Proposed Alterations at 42 Queens Grove, NW8

PROPOSED FLOOR PLANS

PROPOSED SECTIONS

PROPOSED ELEVATIONS

FIRST FLOOR - PROPOSED

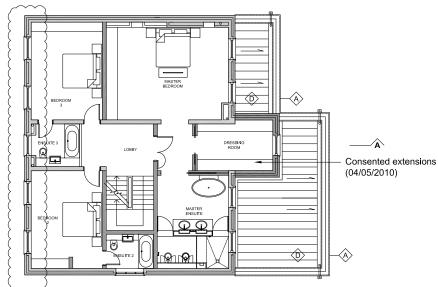
CHANGE IN RELATION TO PLANNING PERMISSION REF.2010/0945/P - REDUCED NUMBER OF WINDOWS TO FRONT ELEVATION (APPROVED ON 6TH APRIL 2011, REF.2011/0405/P) REMAINS UNCHANGED IN RELATION TO APPROVED VARIATION SCHEME REF.2011/0405/P

SECTION A-A - PROPOSED

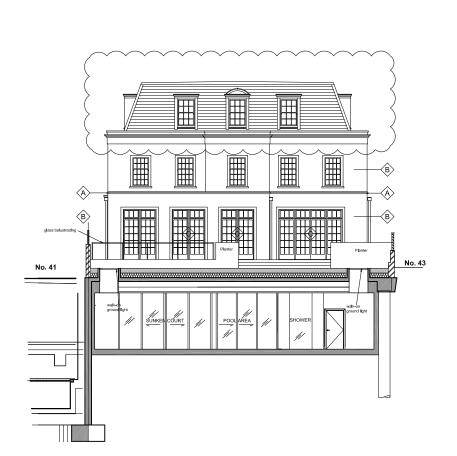
CHANGE IN RELATION TO PLANNING PERMISSION REF.2010/0945/P - INCREASED MANSARD ROOF PITCH
CHANGE IN RELATION TO CONSENTED VARIATION SCHEME REF.2011/0405/P - INCREASED MANSARD ROOF PITCH, REINSTATED PARAPET

SECTION B-B - PROPOSED

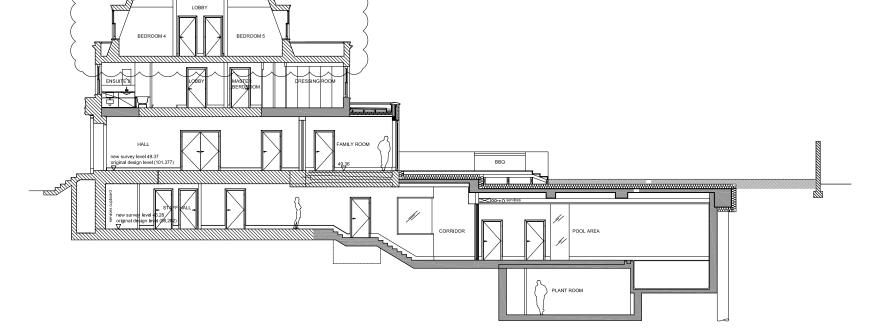
CHANGE IN RELATION TO PLANNING PERMISSION REF.2010/0945/P - INCREASED MANSARD ROOF PITCH
CHANGE IN RELATION TO CONSENTED VARIATION SCHEME REF.2011/0405/P - INCREASED MANSARD ROOF PITCH, REINSTATED PARAPET

SIDE (WEST) ELEVATION - PROPOSED

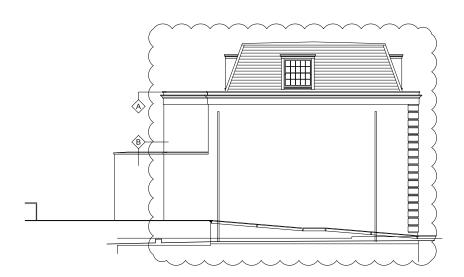
CHANGE IN RELATION TO PLANNING PERMISSION REF.2010/0945/P - INCREASED MANSARD ROOF PITCH, FACADE DETAILING AMENDMENTS CHANGE IN RELATION TO APPROVED VARIATION SCHEME REF.2011/0405/P - INCREASED MANSARD ROOF PITCH, FACADE DETAILING AMENDMENTS, REINSTATED PARAPET

FRONT ELEVATION - PROPOSED

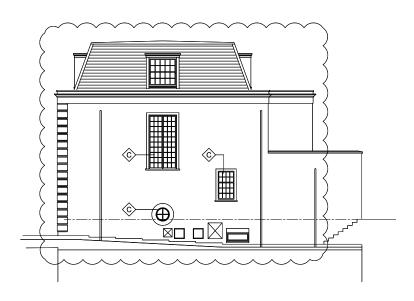
CHANGE IN RELATION TO PLANNING PERMISSION REF.2010/0945/P - INCREASED MANSARD ROOF PITCH, FACADE DETAILING AMENDMENTS AND APPROVED (REF.2011/0405/P) REDUCED NUMBER OF WINDOWS TO FRONT ELEVATION CHANGE IN RELATION TO APPROVED VARIATION SCHEME REF.2011/0405/P - INCREASED MANSARD ROOF PITCH, FACADE DETAILING AMENDMENTS AND REINSTATED PARAPET
